Metro Martin Place

Sydney Metro and Over Station Development Design Review Panels

DRP #06

7 August 2018

TOWER - SOUTH WALL CURRENT DESIGN
METRO MARTIN PLACE | SOUTH TOWER DESIGN CONCEPT

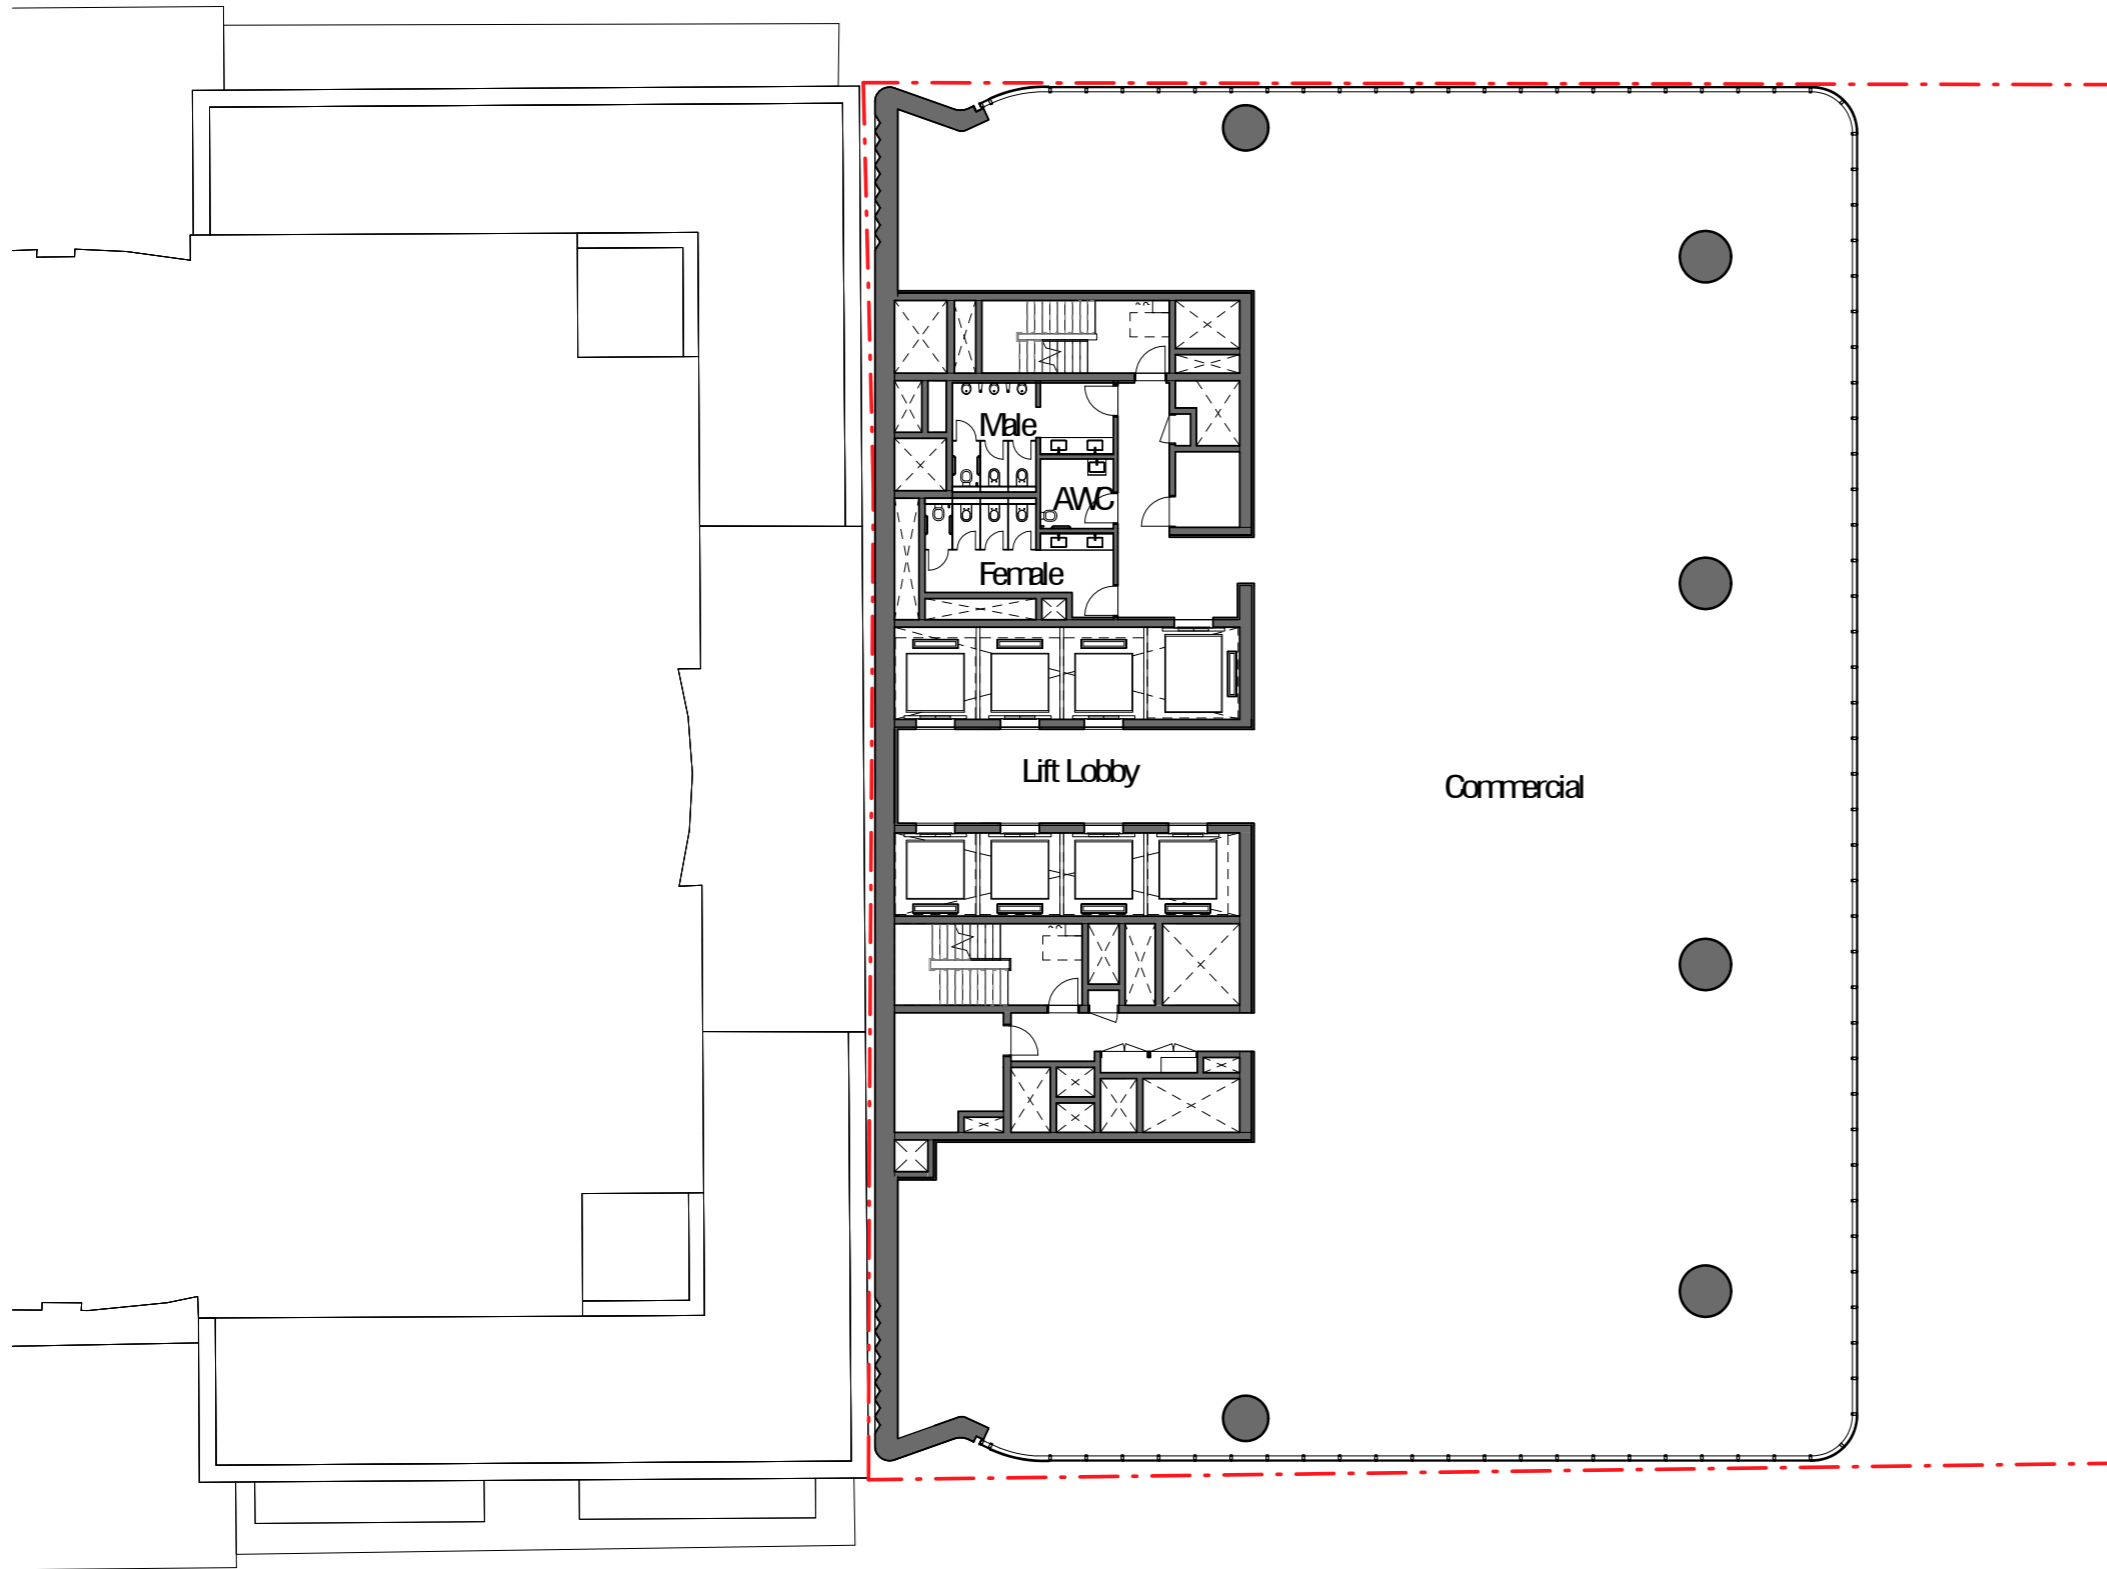
The OSD DRP has indicated the intent of the setbacks above the podium has not been met by the tower and has recommended increasing the setbacks at the south east and south west corners '*to improve architectural expression and urban design outcomes for the block*'.

‘While the proposed decoration of the south facade has merit as a strategy to mitigate the blankness of the southern elevation , we do not support the current approach to this elevation. We strongly recommend strengthening the resolution of this in relation to the elevation as a whole, considering views from both Castlereagh and Elizabeth Streets.

- the intent of the setback above the podium has not been met by the tower, which extends the full height and width of the approved envelope and is likely to result in a poor urban design outcome for the southern end of the street block and adjacent development
- we recommend increasing the setbacks at the south east and south west corners of the tower to improve architectural expression and urban design outcomes for the block.’

Tzannes presentation, provided under separate cover, responds to the OSD DRP's feedback.

Southern Lens

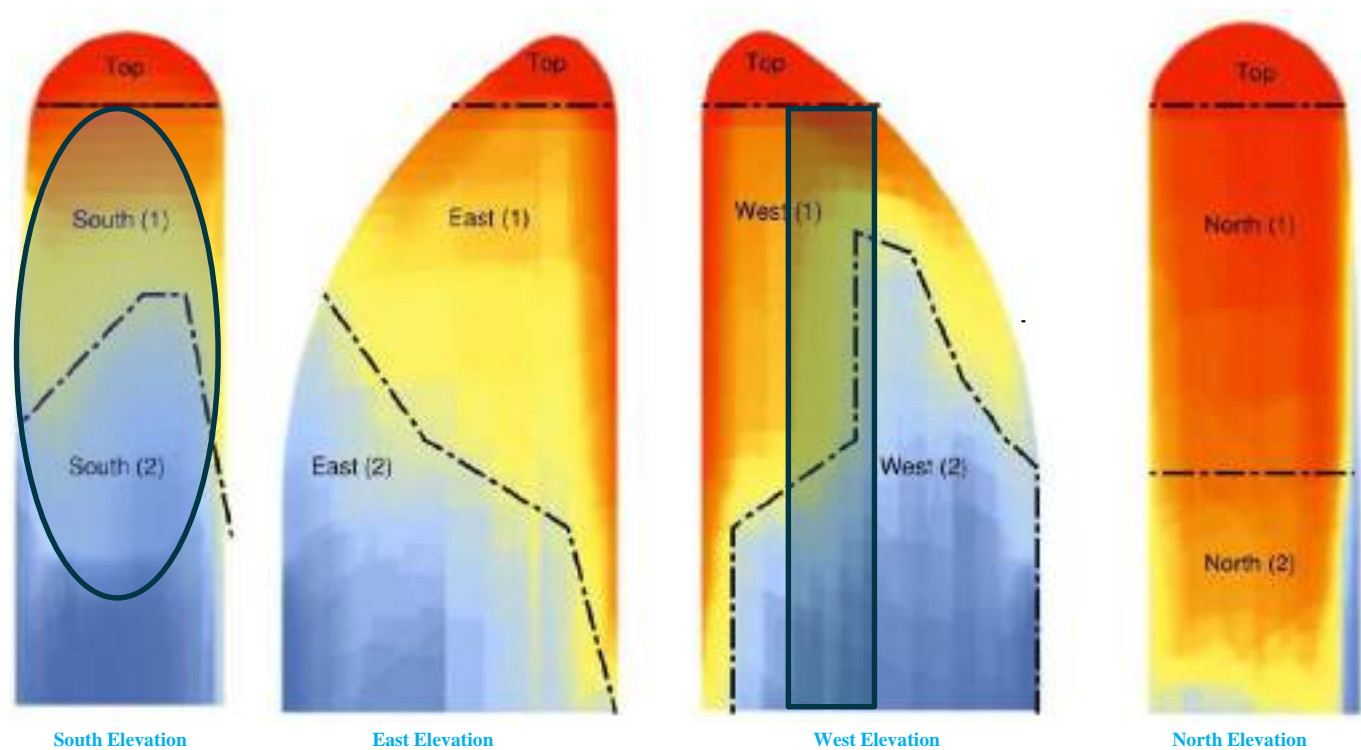
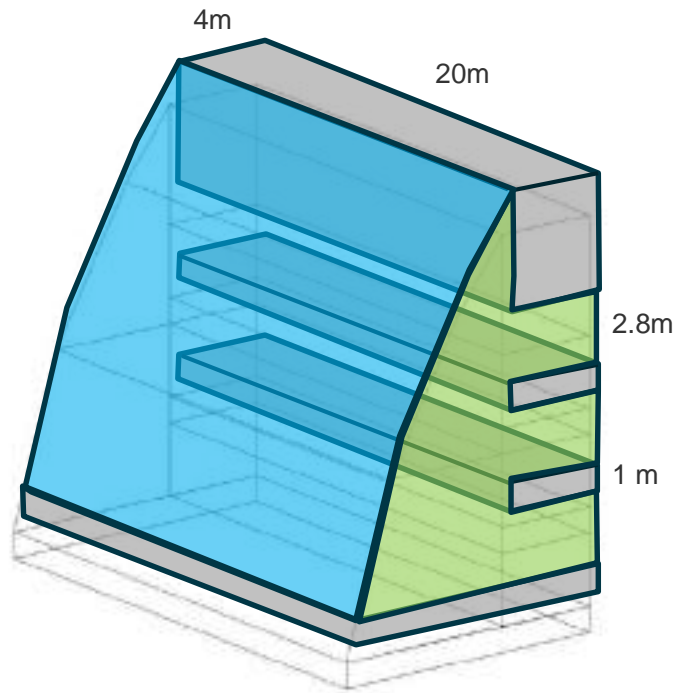
The OSD DRP has requested further details on Macquarie's Comfort Levels as it relates to the North Tower shading and transparent glazing to the western façade.

- Southern façade is a breakout space
- Breakout spaces allow greater variability of comfort
- Target comfort for breakout spaces is PMV +/- 1.5 (similar to retail breakout spaces)
- If using as office then Blinds deployed similar to Office façade PMV +/- 1.0

- VLT >60%
- SHGC 0.30
- Pelmet with allowance for future blind

Sun Studies August 2018 Results

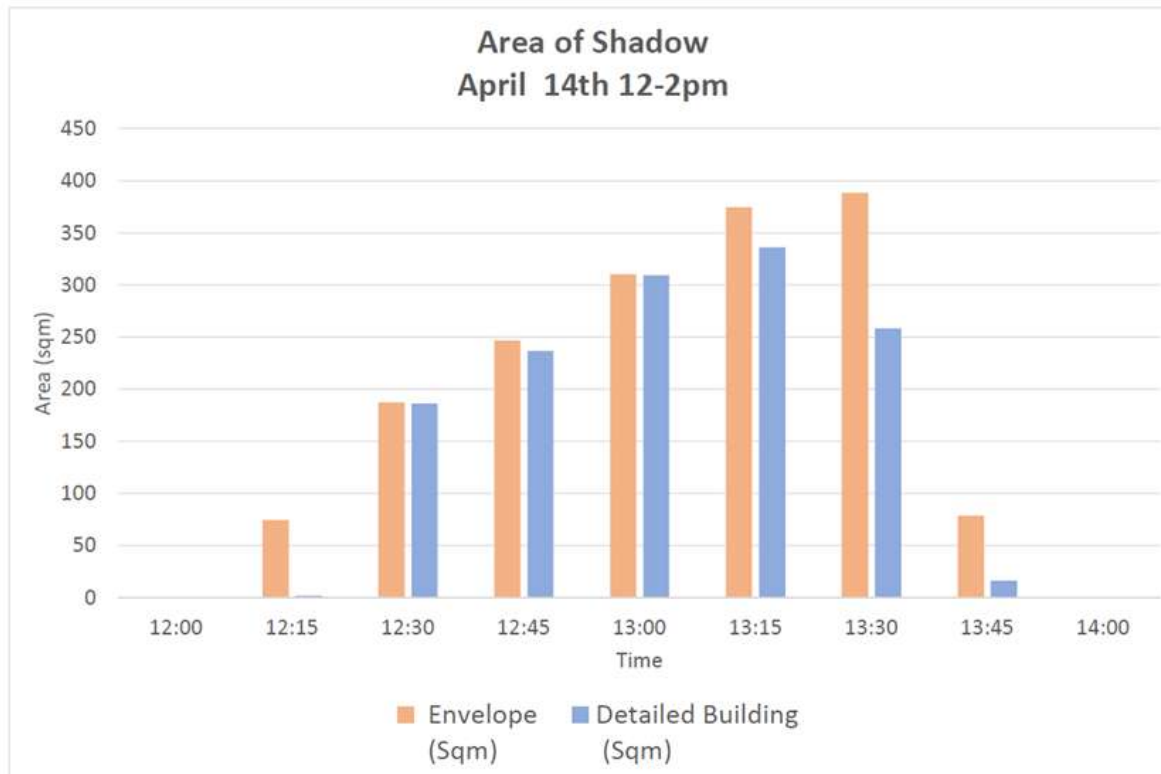
The Sydney Metro DRP and OSD DRP requested shadow analysis to demonstrate solar access to Martin Place. The requested analysis has been completed and distributed to both DRPs.

The Sydney Metro DRP and OSD DRP have requested shadow analysis of the North Tower. The Stage 1 SSDA Approval for the OSD includes the following overshadowing condition which the detailed building form is required to comply with for the Stage 2 SSDA submission.

Reduction in area of shadow from
approved envelope to detailed
building form
14 April 12-2pm

316.8m² = 19.1%
